Following the Hawke’s Bay Regional Council peer review meeting held on 5 June 2018, a number of minor matters raised by the peer reviewers were recorded. These are noted and clarified below where necessary.

ADCP Current Speed [mm/s] Upper Water Column

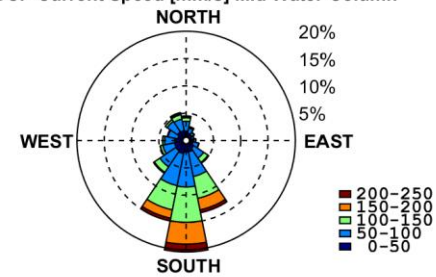
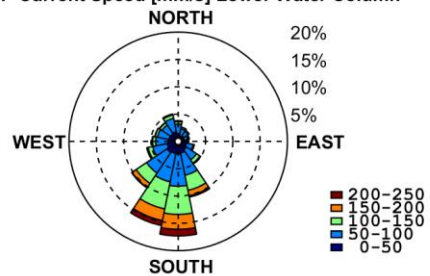
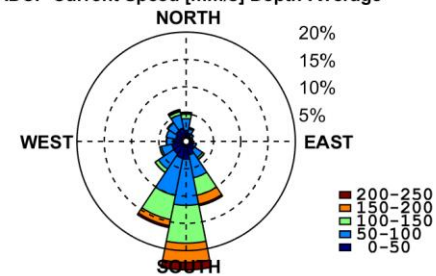
<p>Furthermore, are any additional conditions proposed by Napier Port?</p>		<p>Napier Port is not averse to an extension of conditions 10 and 11 in 26.3 requiring bathymetric surveys of the disposal location and nearby areas to an extent and at a frequency to be agreed with HBRC.</p>
		<p>Ongoing ADCP current data at the proposed offshore disposal ground is being collected and has been aggregated in Error! Reference source not found. figure below across the following contiguous deployments:</p> <ul style="list-style-type: none"> • 8th Dec 2016 – 3rd Feb 2017 • 1st March 2017 – 1st June 2017 • 29th July 2017 – 18th Sept 2017 <p>It can be seen from the figure below that the currents are predominantly toward the south, indicating that the fine sediments would be carried away from Pania Reef.</p>

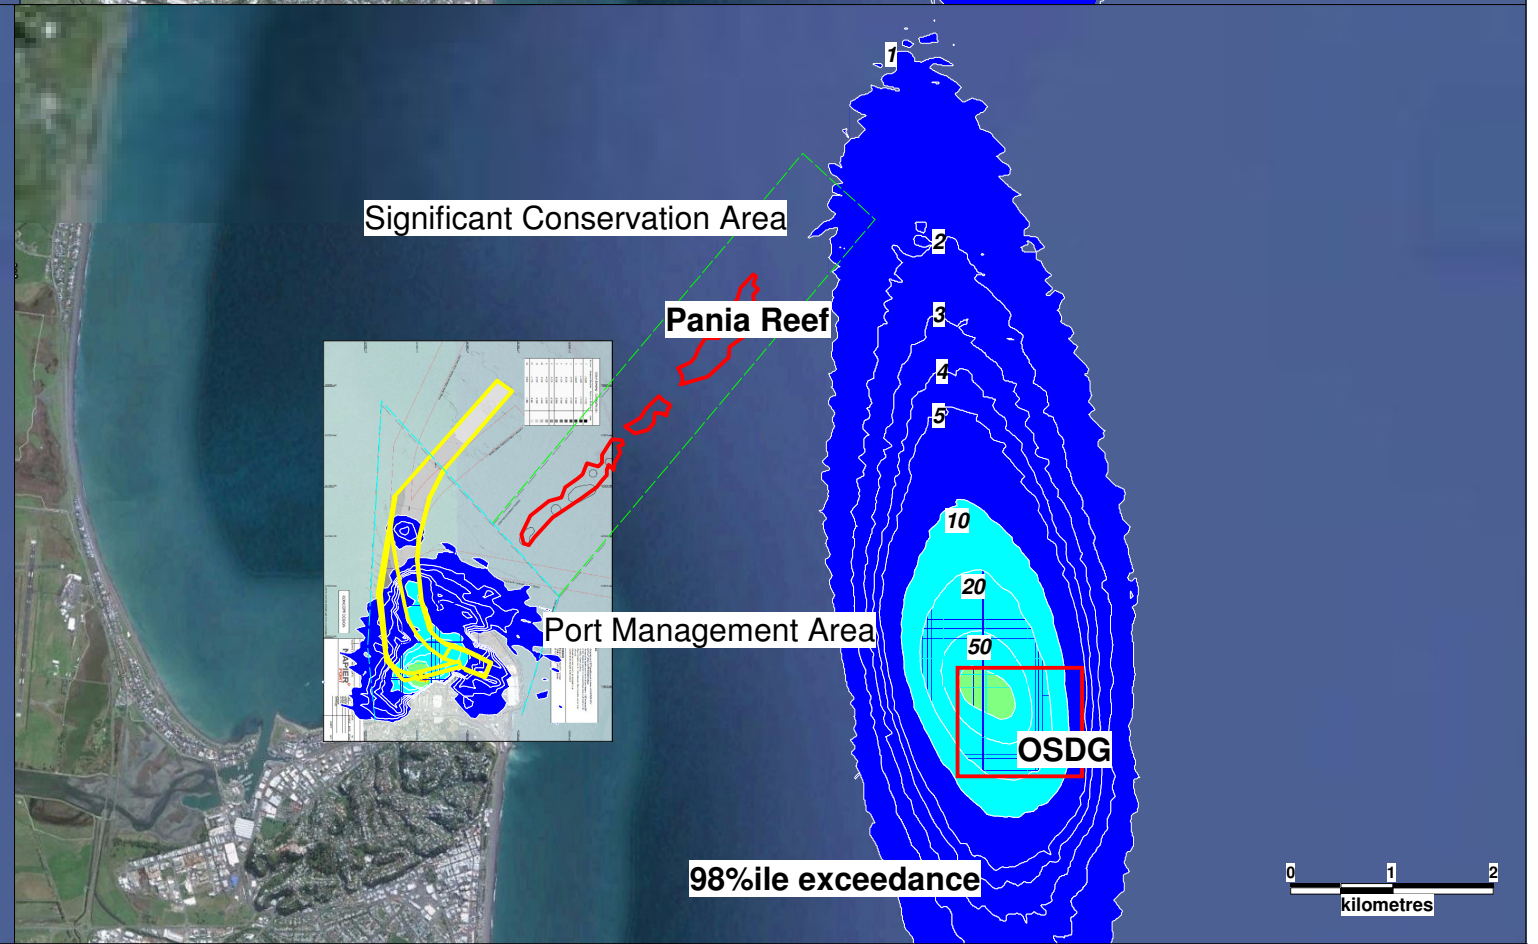
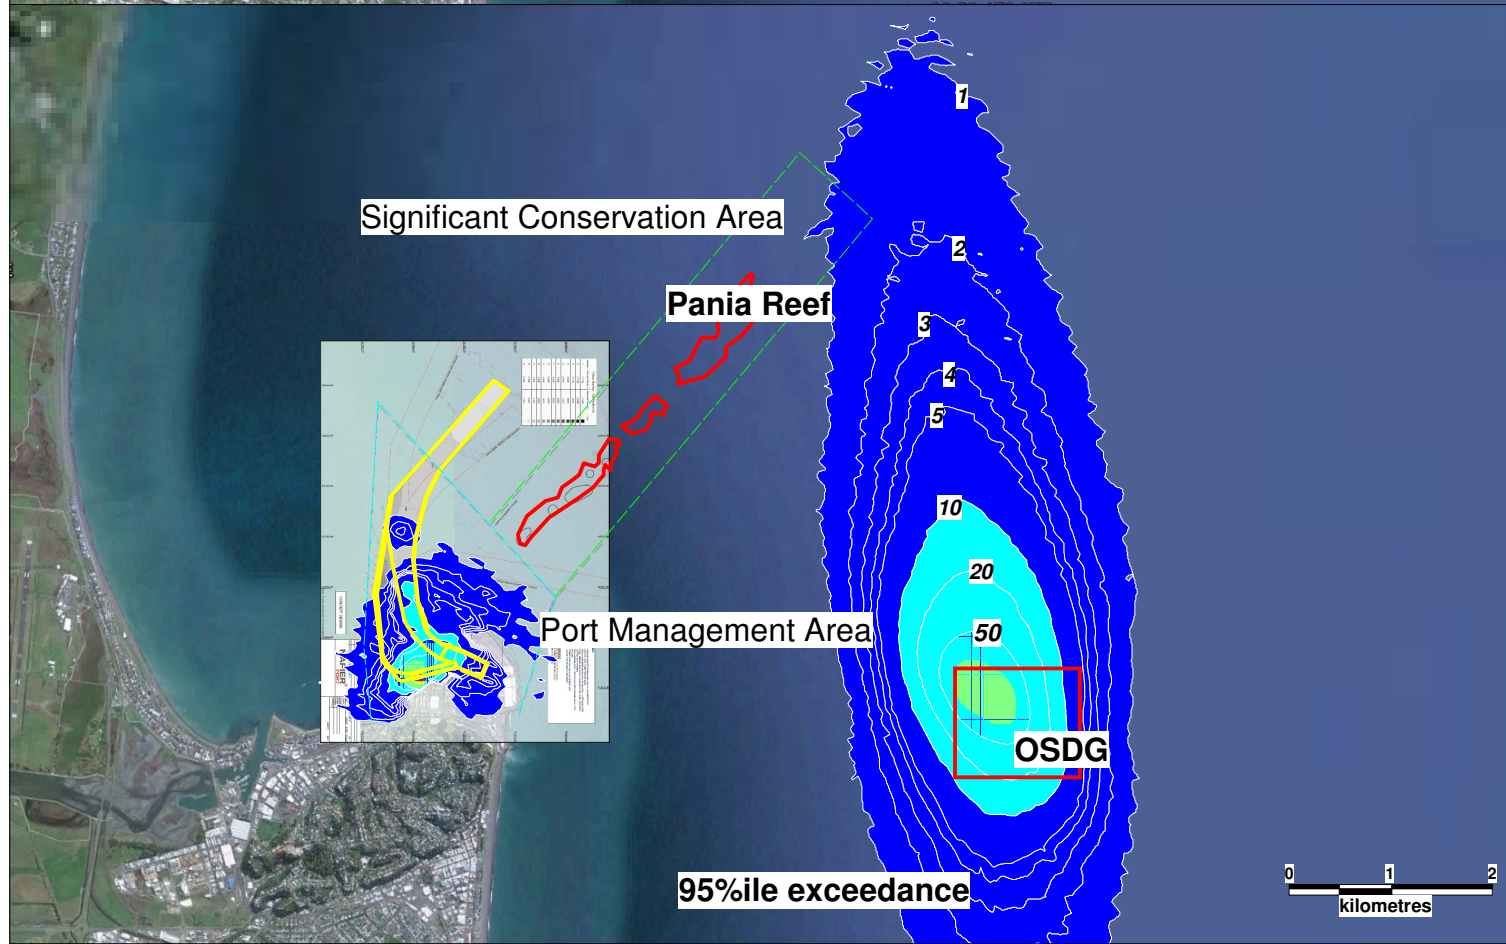
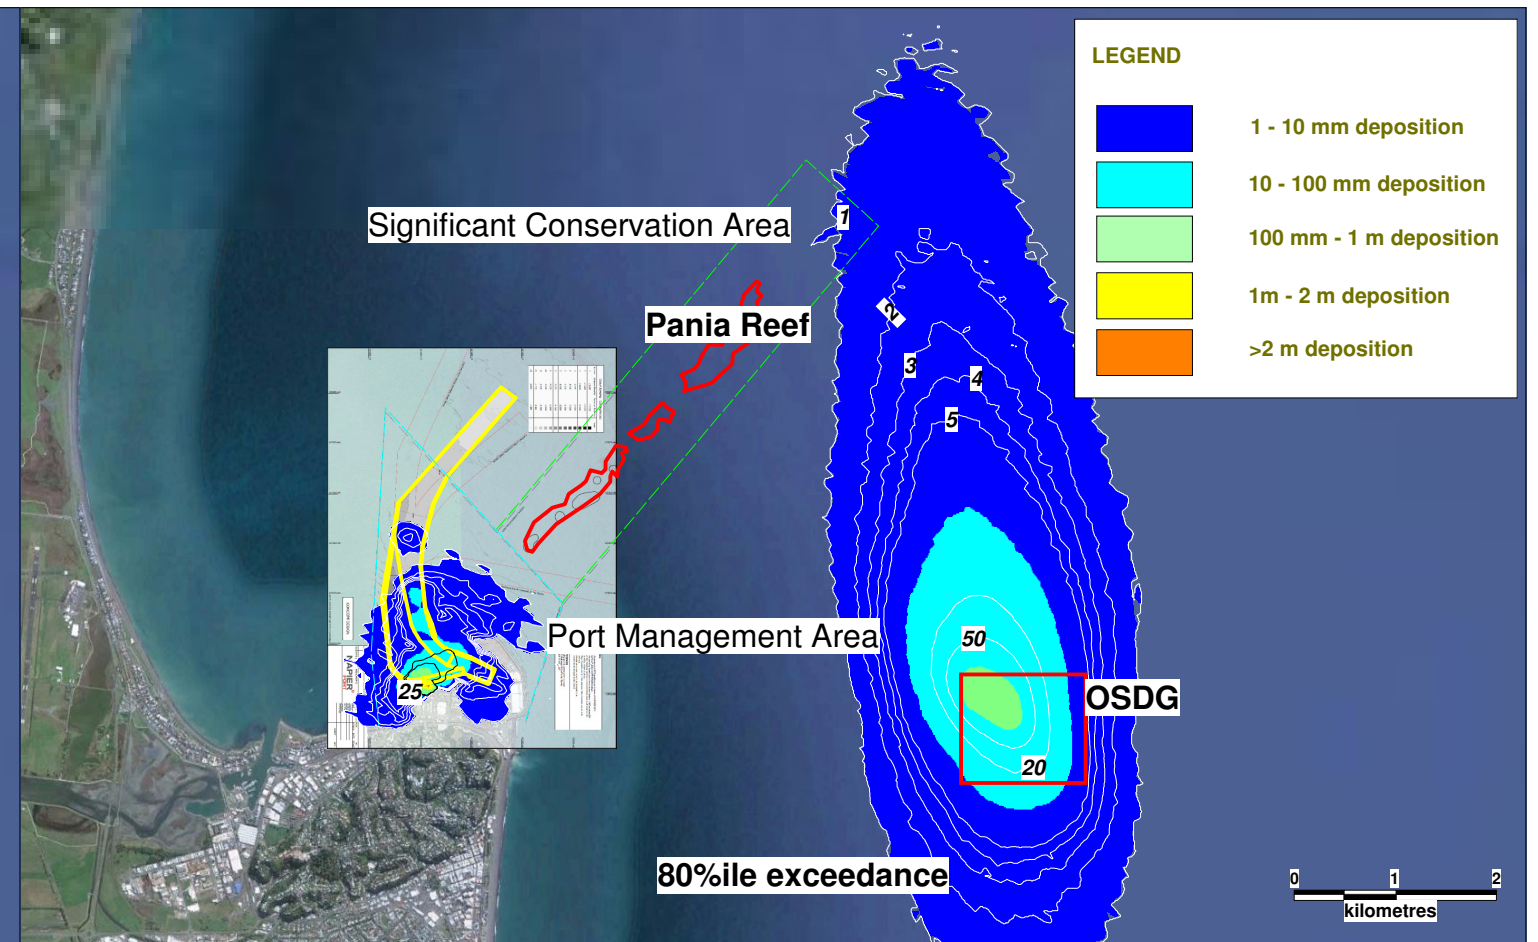
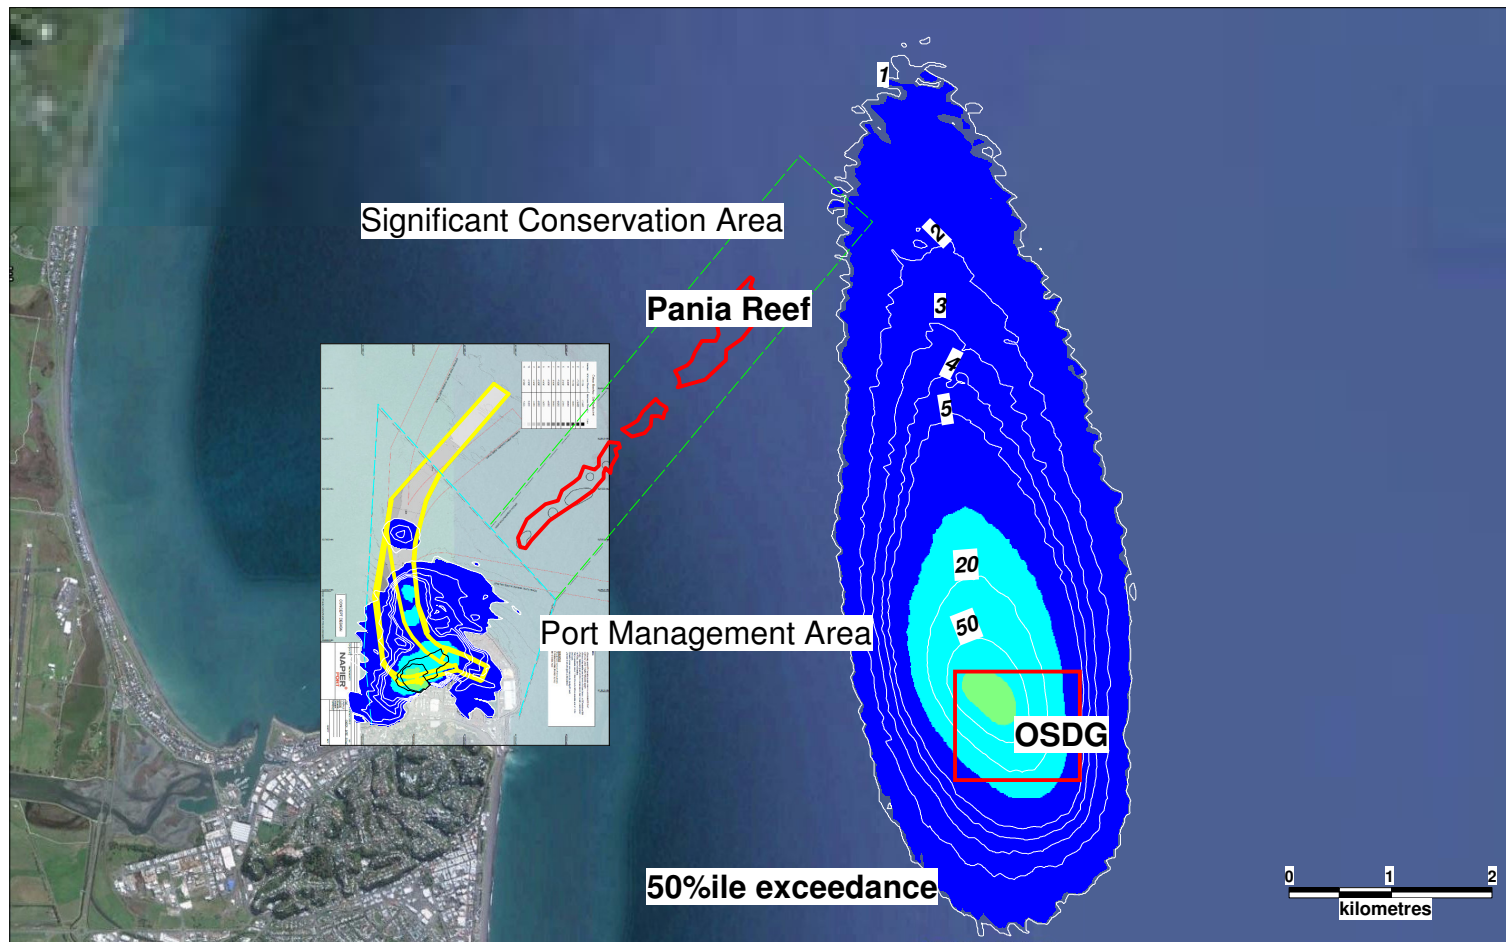
<p>Appendix E and F provide information on re-suspension. However, material finer than coarse silt has not been modelled. Why has this material not been modelled? What are the effects associated with the re-suspension of this material?</p>	<p>Clay and silt fractions are included in the deposition modelling shown in Figs 29 and 35 of Appendix E (see Sections 5.3 to 5.5). This addresses initial deposition. The explanation of why clay and fine silt are not included in the resuspension analysis is given in Section 4.2.2 of Appendix F. The assumptions relating to resuspension at the offshore disposal grounds are set out in Section 6 of Appendix F.</p>
	<p>Please provide modelling of the potential effects on Pania Reef and the subsequent effects on other reef systems if the dredged material is disposed of at a greater depth. Please model a disposal site in 25m of water and 30m of water. This work should be done in response to the concerns raised by submitters and to ensure that alternative</p>	<p>The discussion and nature of investigations of alternative disposal areas is set out under Section 5.4.1 of the AEE. As the effects are considered to be less than minor, and avoid all effects of the types set out in NZCPS Policy 11(a), they must be evaluated primarily in terms of NZCPS Policy (b)(iv). Conditions to address these aspects have been proposed. A full policy analysis will be provided in evidence for the hearing.</p>
